| Illinois Tollway Standard Drawing Revisions |

| Section E | Maintenance of Traffic |                                                                                                                                                                                                                                                                     |                       |
|           | Standard               | Modification Summary                                                                                                                                                                                                                                                | Effective: 03-01-2025 |

## TEMPORARY GORE DETAILS

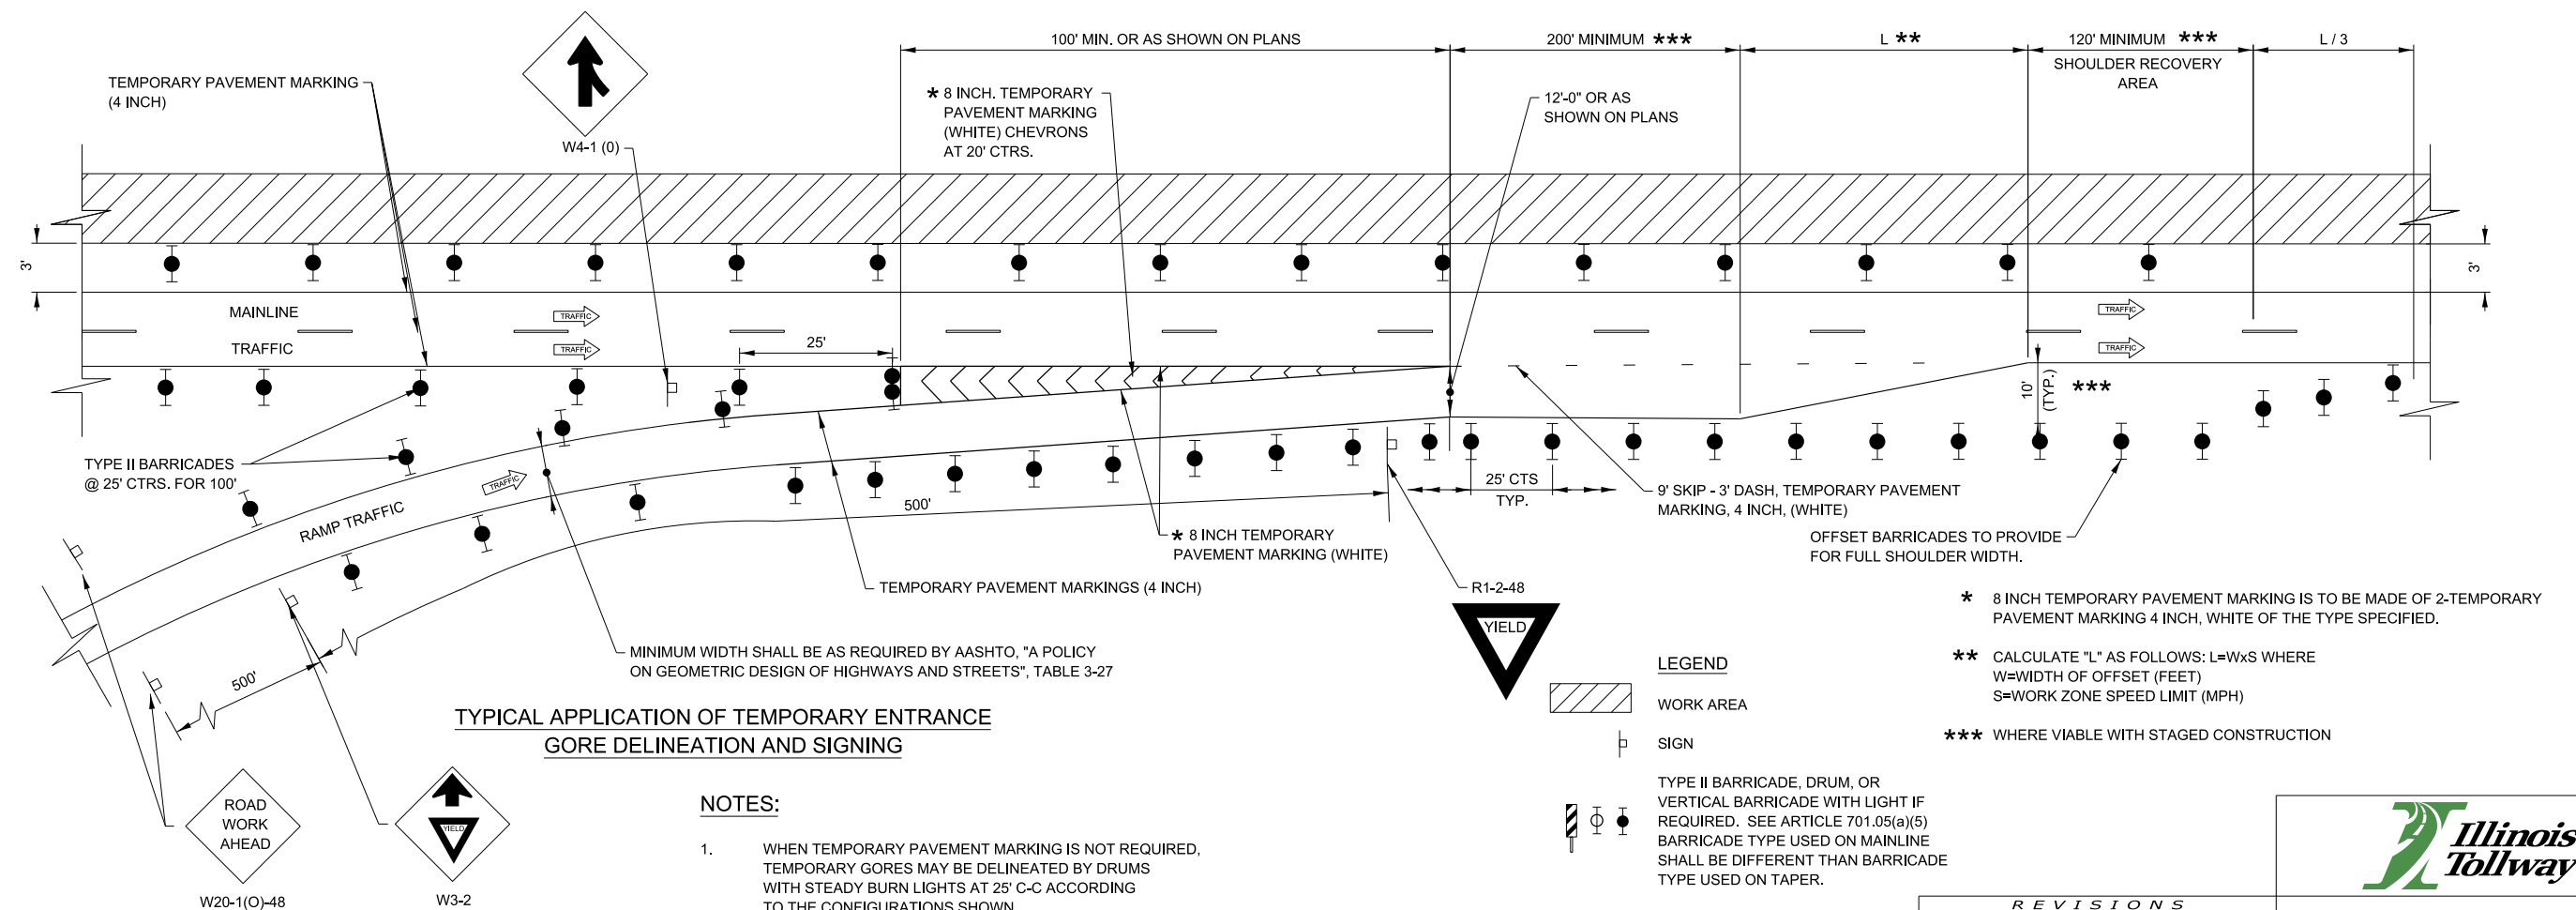
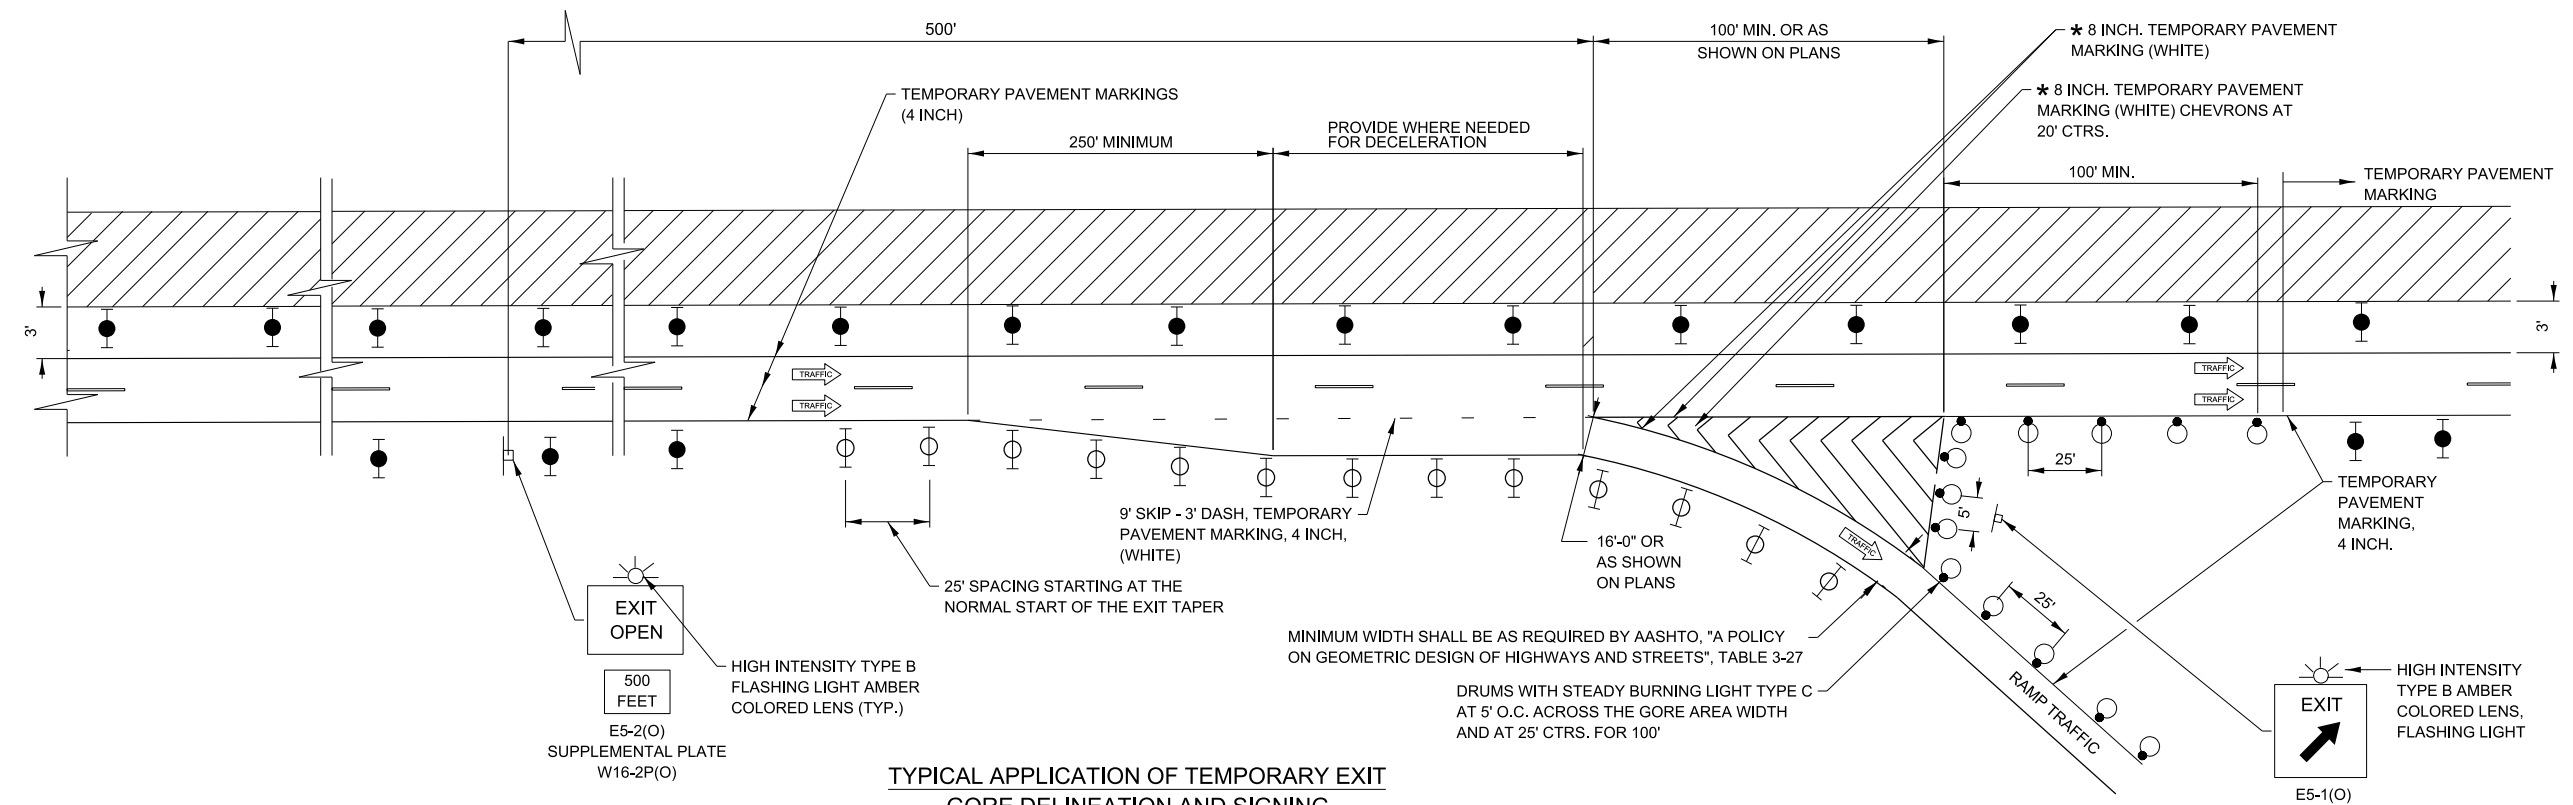
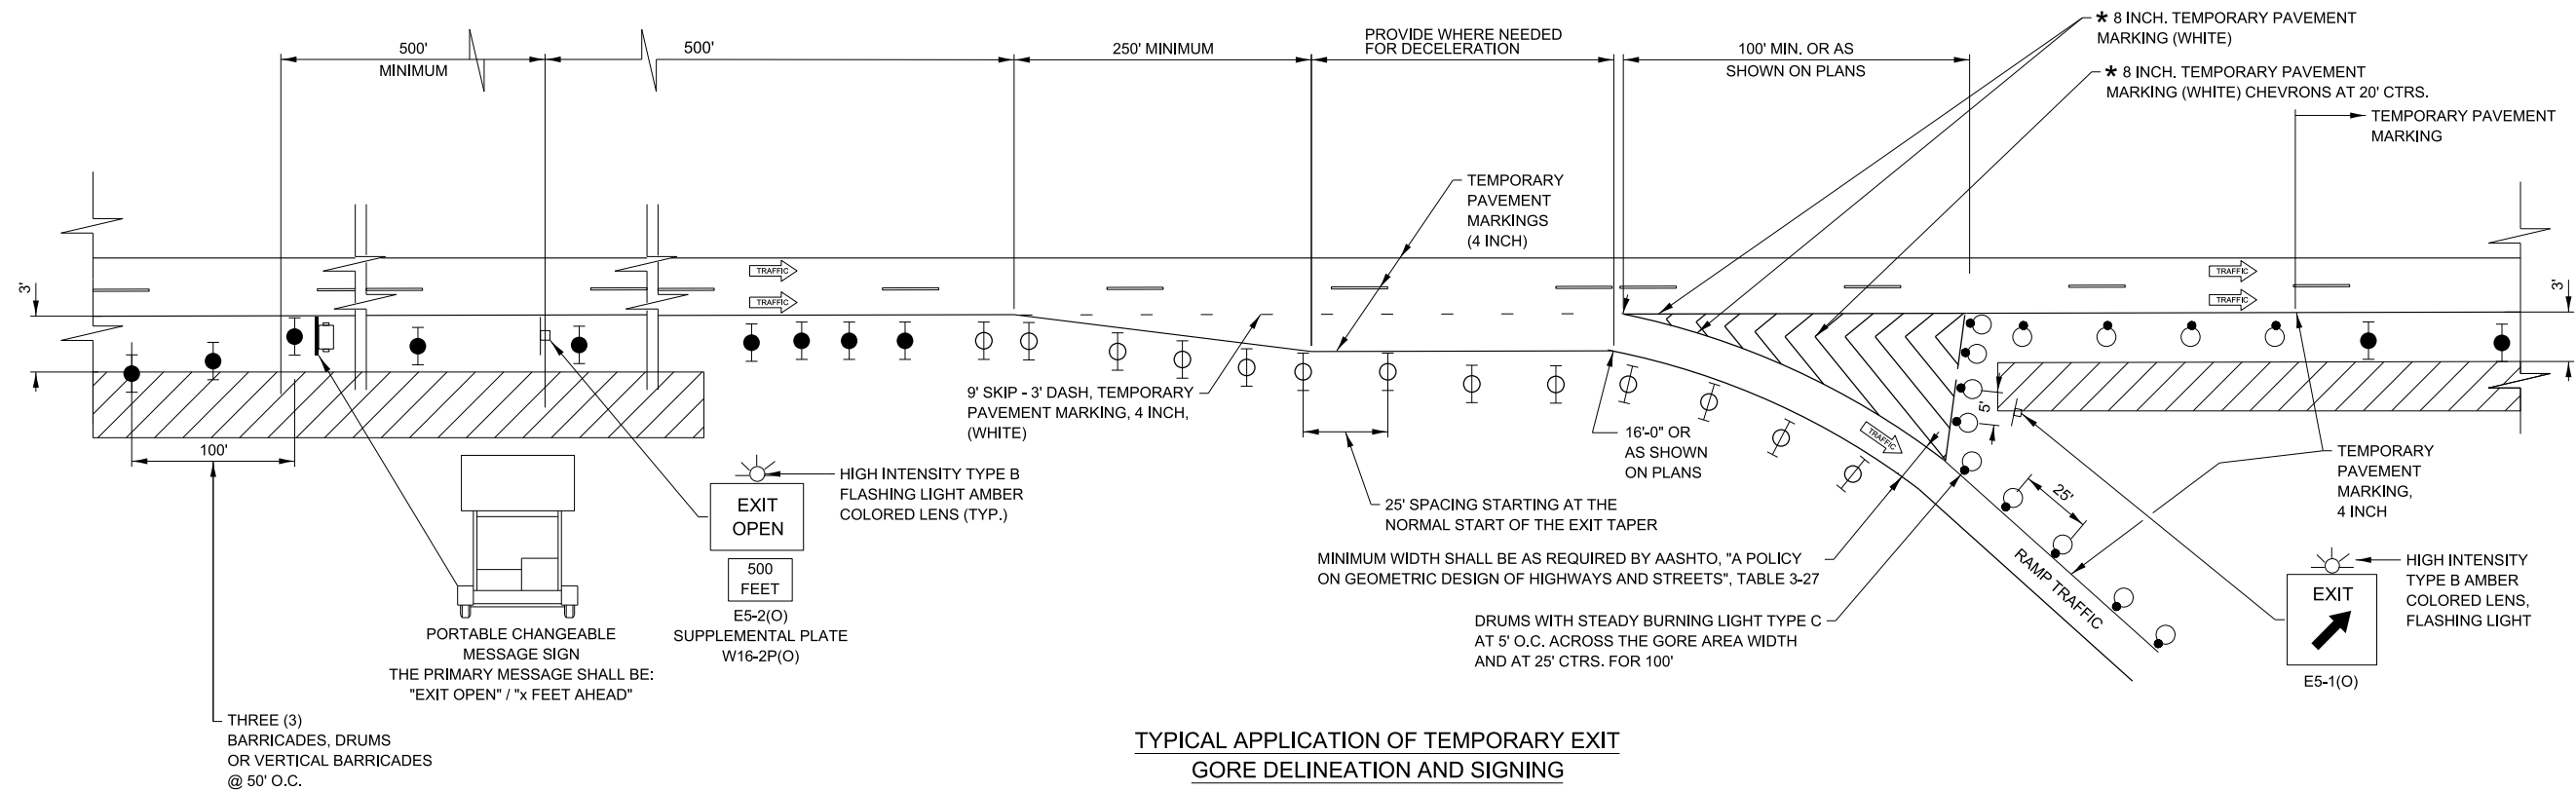
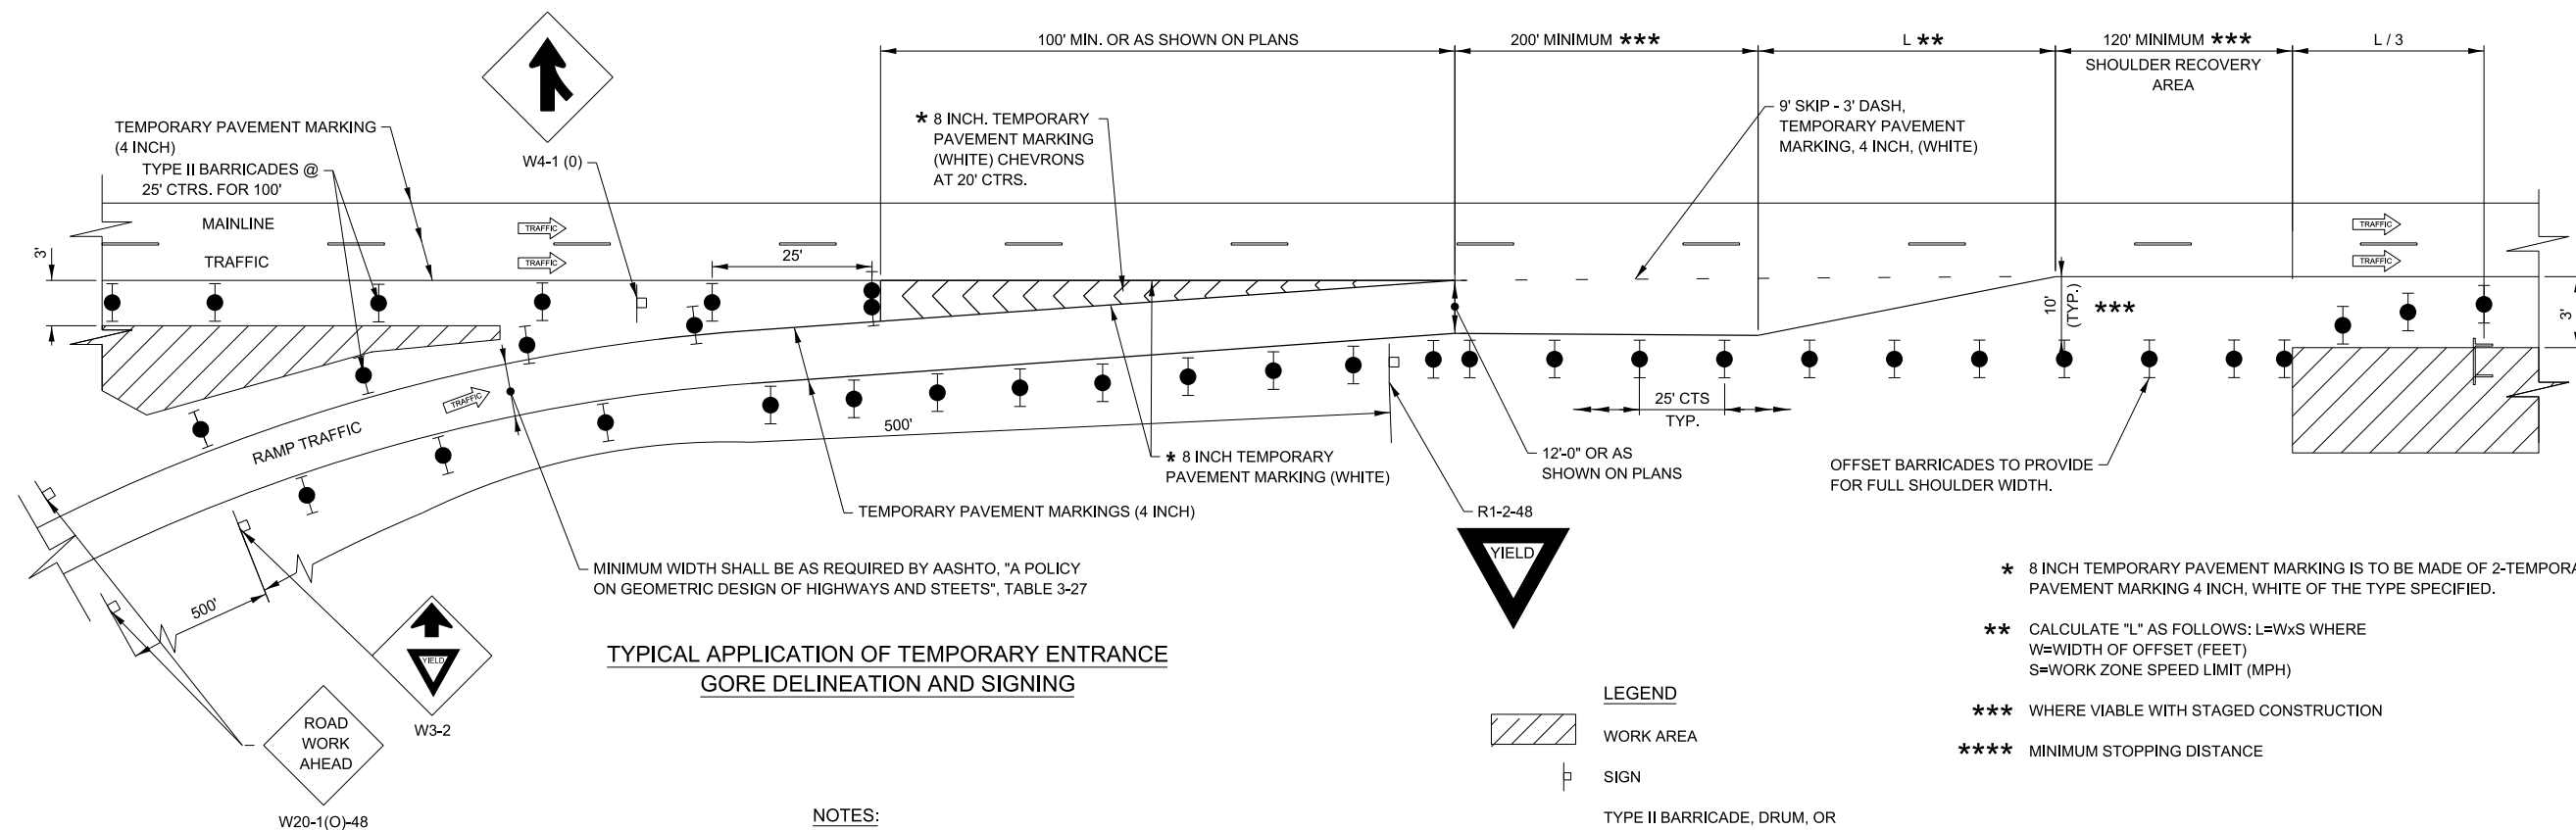
| Section E | Maintenance of Traffic |                                                                                                                                                                                                                                                                     |                       |
|-----------|------------------------|---------------------------------------------------------------------------------------------------------------------------------------------------------------------------------------------------------------------------------------------------------------------|-----------------------|
|           | Sheets 1 & 2           | Revised work area hatching to increase buffer to active lane                                                                                                                                                                                                        |                       |

| DATE       | DESCRIPTION                                                                                |
|------------|--------------------------------------------------------------------------------------------|
| 03-01-2025 | REDUCED WORK AREA TO PROVIDE 3 FT<br>BUFFER TO ACTIVE LANES                                |
